07-06-2022

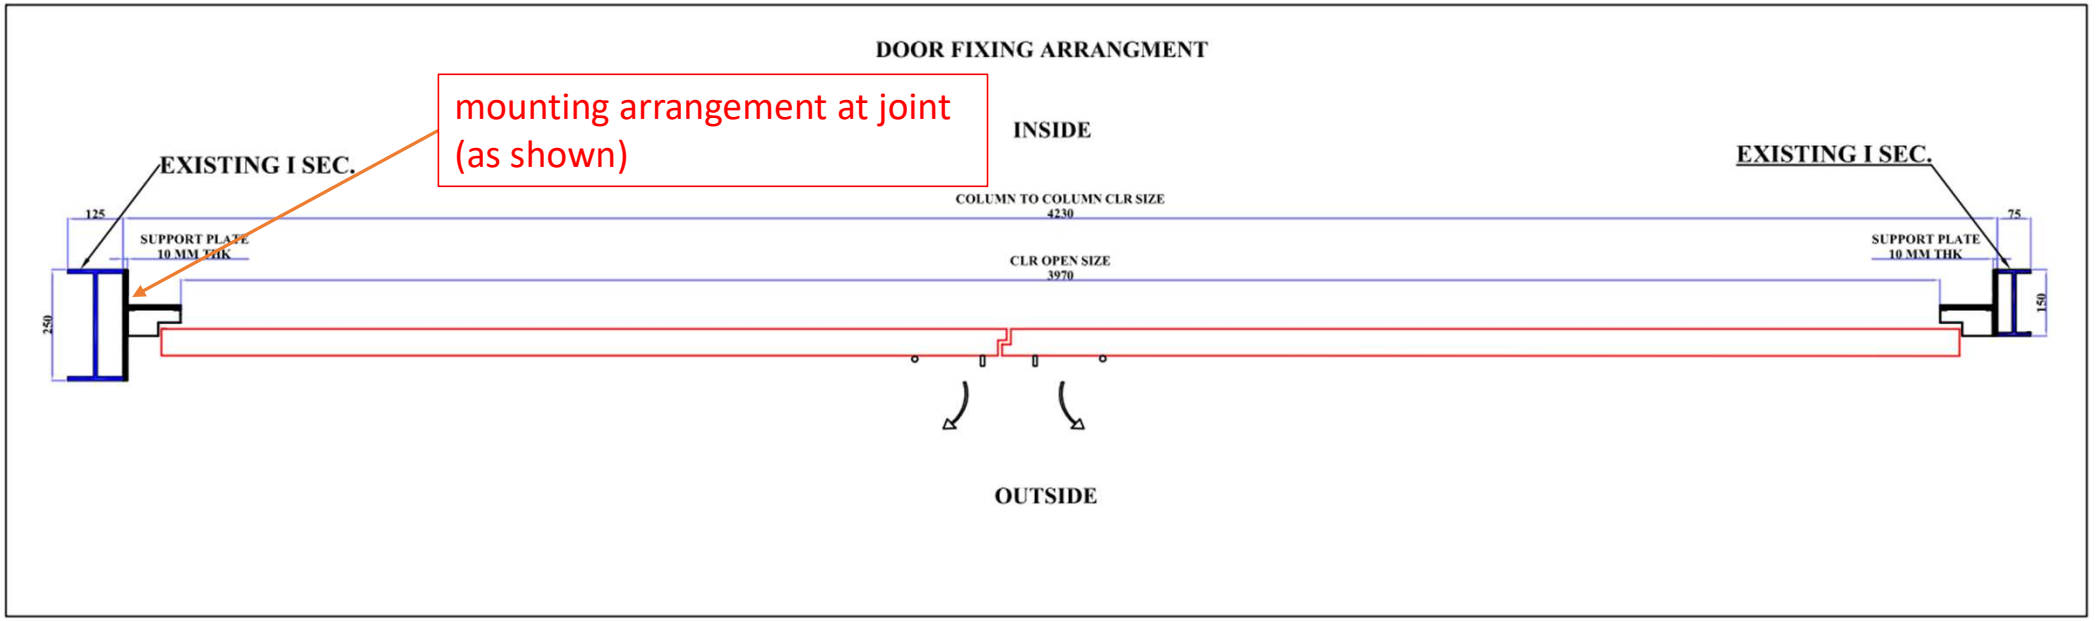
1) Alignment for all hinges should be proper, so swing operation must be work smoothly.
2) Also mention the no. of supports/hinges provided to each doors and frames
3) Please make sure the mounting arrangement at joint(as shown) should sustain the wind pressure of 150 km/hr, so increase the thickness of plate.
